INVITATION TO BIDDERS #2023-06
NEW GEOTHERMAL STORAGE TANK
ADDENDUM NUMBER ONE
October 3, 2023

On September 14, 2023, the Oregon Institute of Technology (“Oregon Tech”) published Invitation to Bidders #2023-06 for New Geothermal Storage Tank (“BID”).

OREGON INSTITUTE OF TECHNOLOGY GEOTHERMAL IMPROVEMENTS

1 SITE PLAN - HORIZONTAL TANK
C2 SCALE 1"=10'

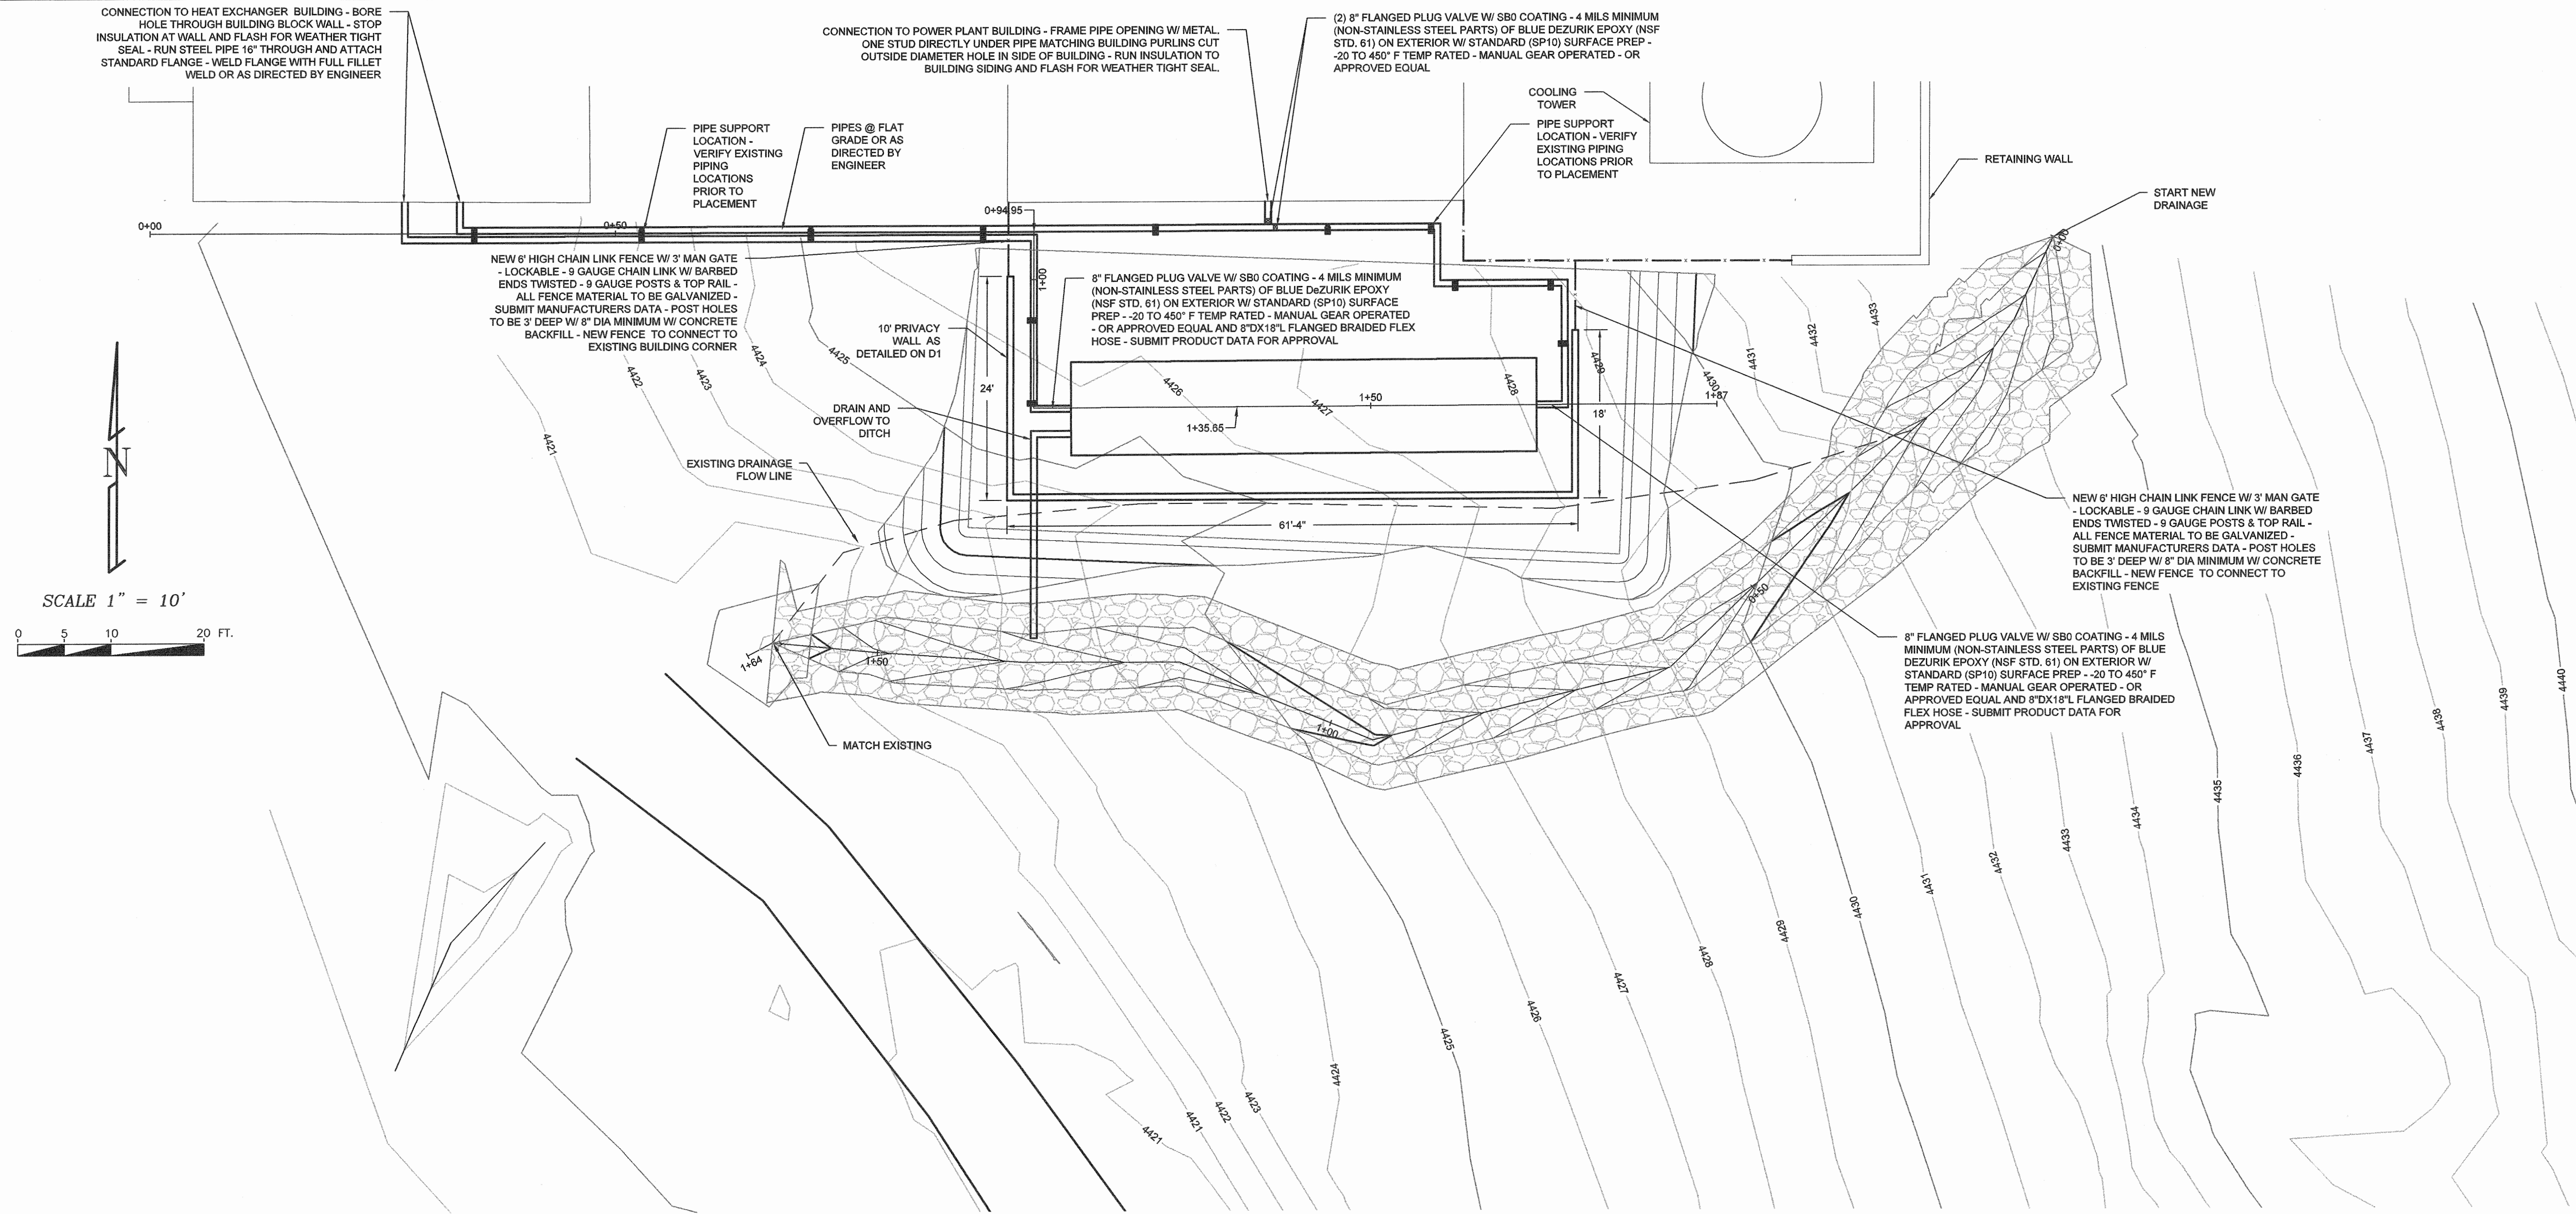
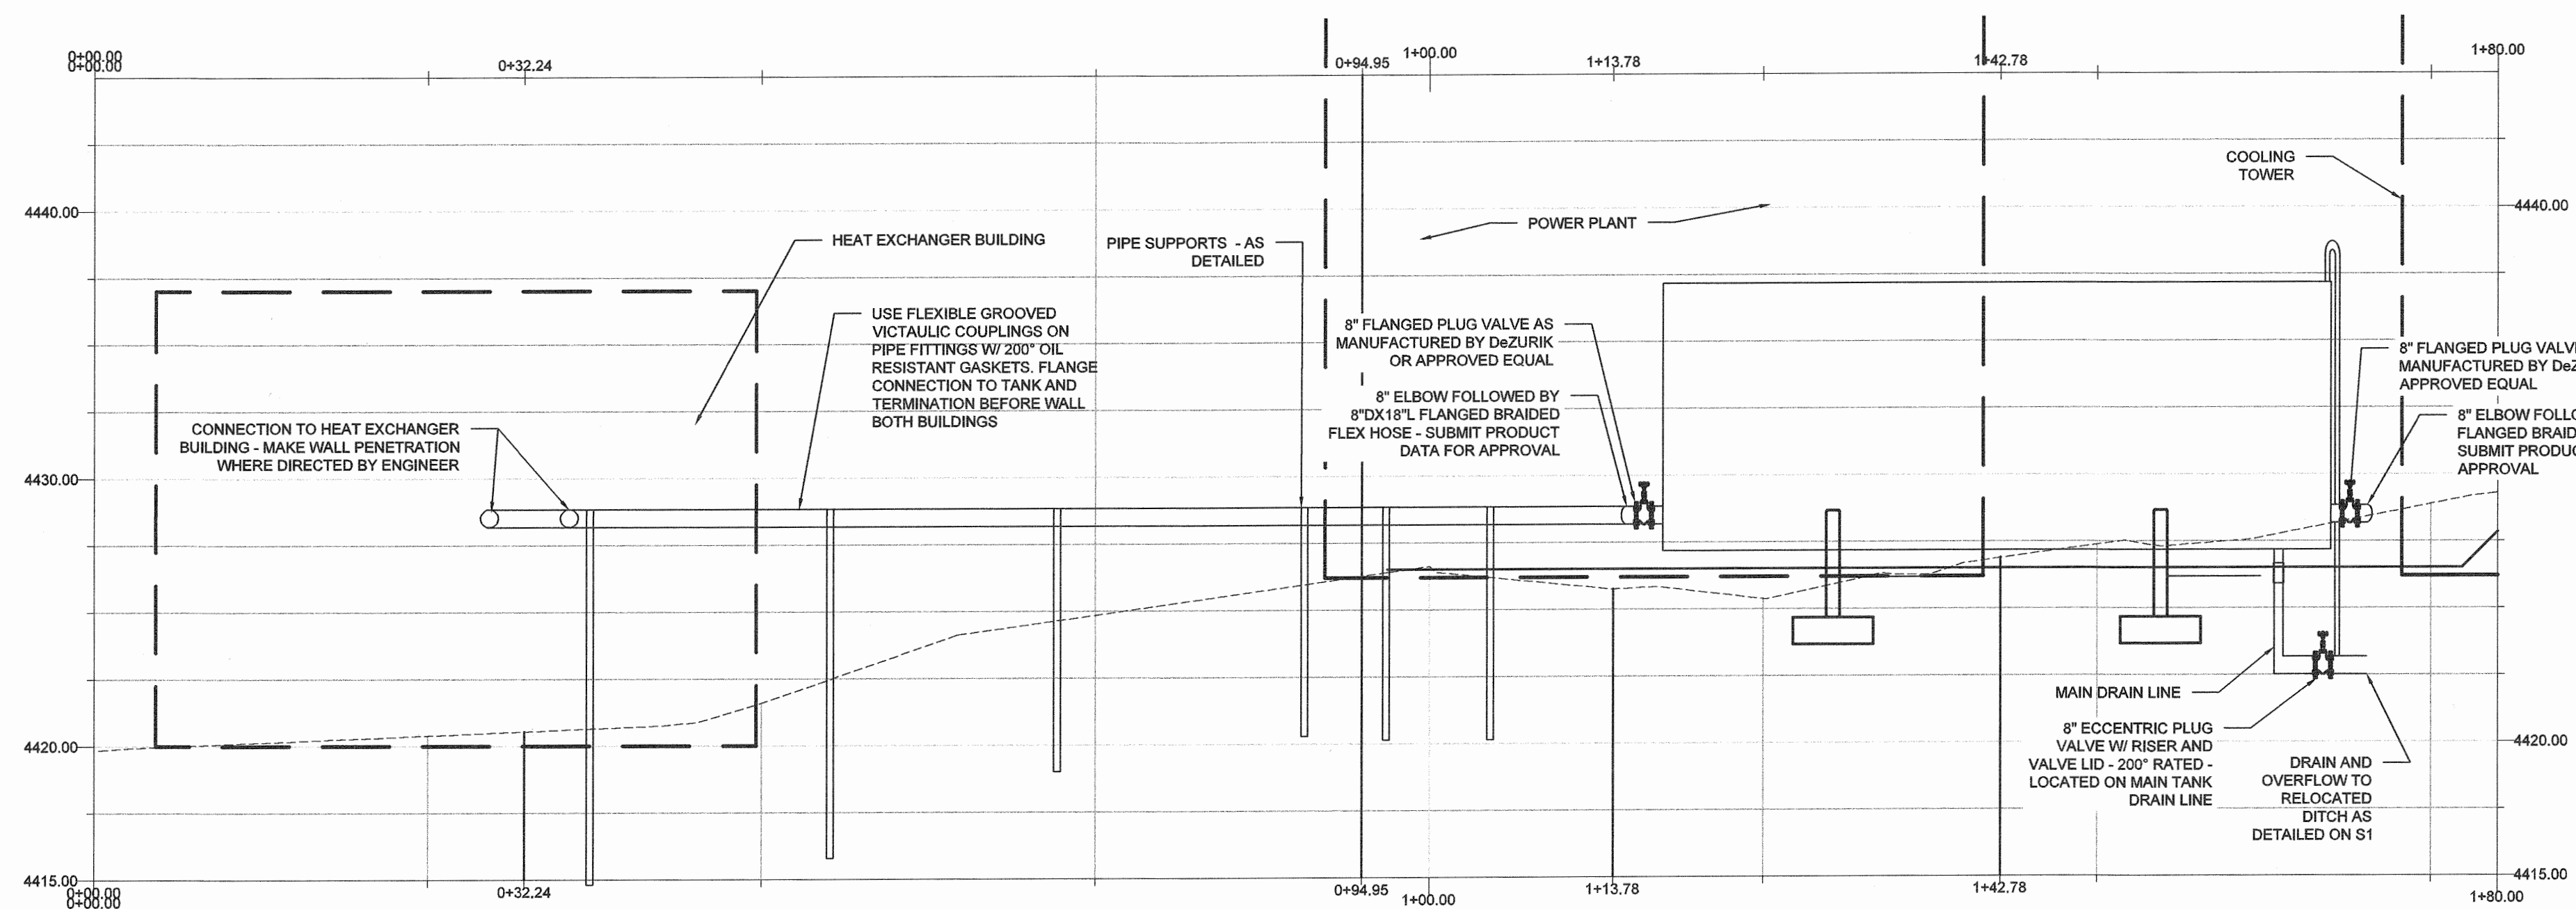
- a. Addition of chain link fencing.
 - b. All valves, fittings, piping, gaskets, etc. must be compatible with two hundred and ten (210) degrees Fahrenheit water.

7 BLOCK WALL SECTION
SCALE: NTS

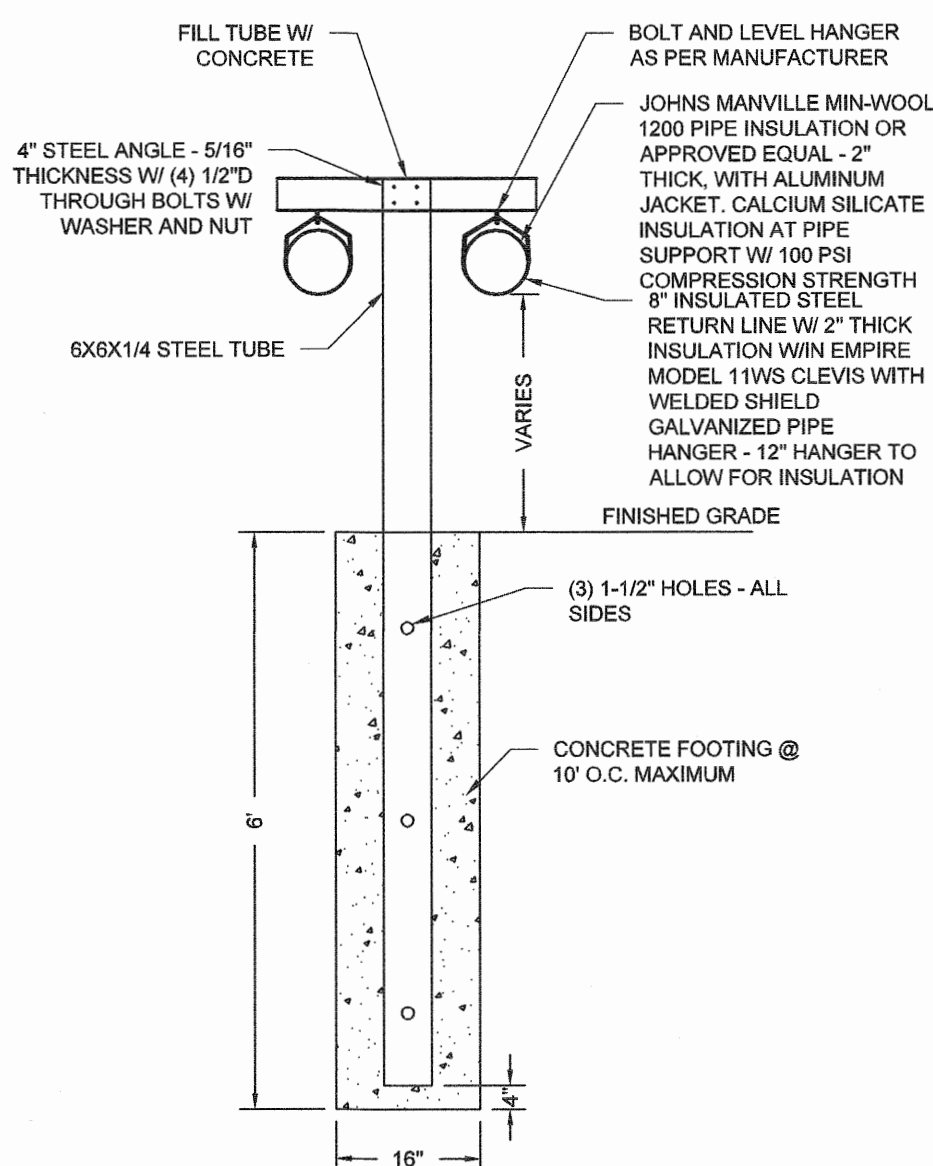
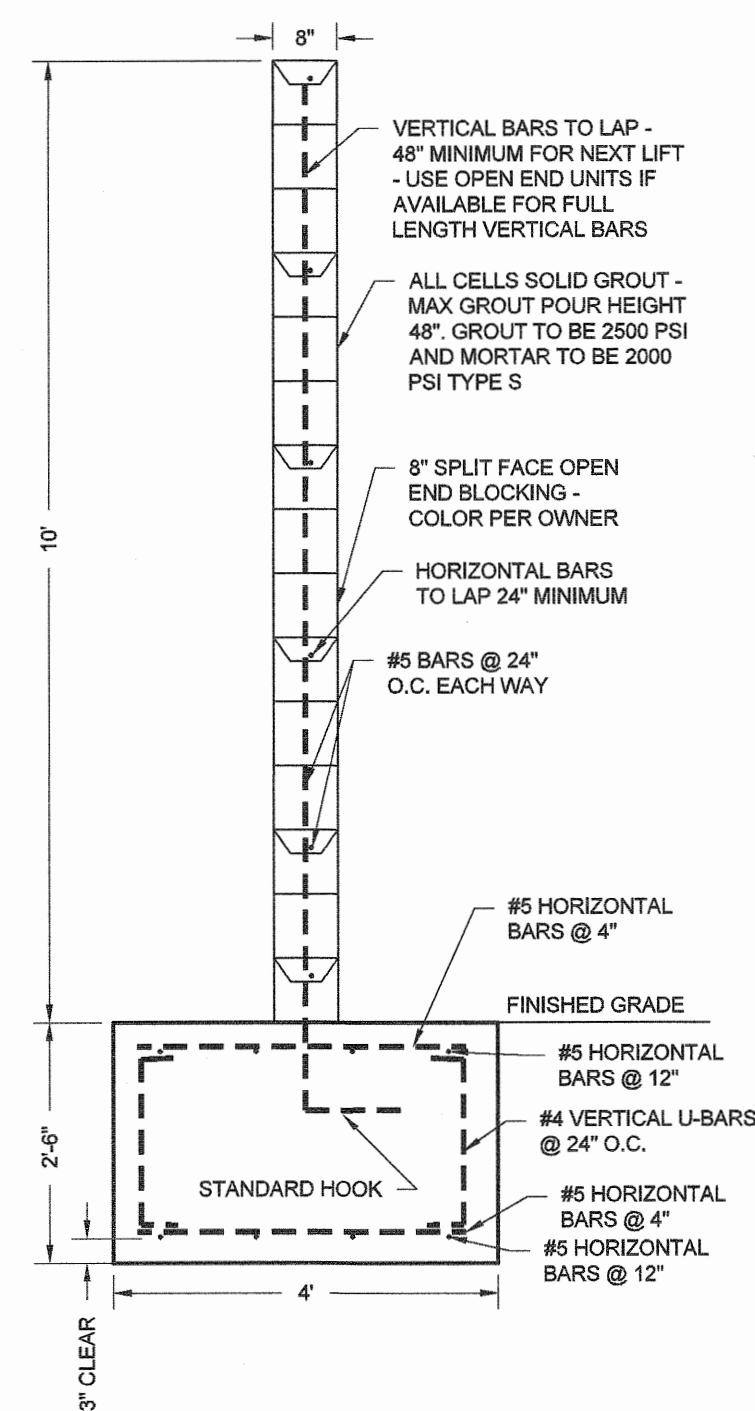
- c. Add flat cap block to block screen wall.
 - d. Vent/overflow combined.
3. The originally published Specifications are removed in their entirety and replaced with the revised “Geothermal Water Storage Tank Specifications Welded Steel Construction – Addendum #1,” attached hereto and incorporated herein as **Exhibit C**. Revisions to the Specifications include the following:
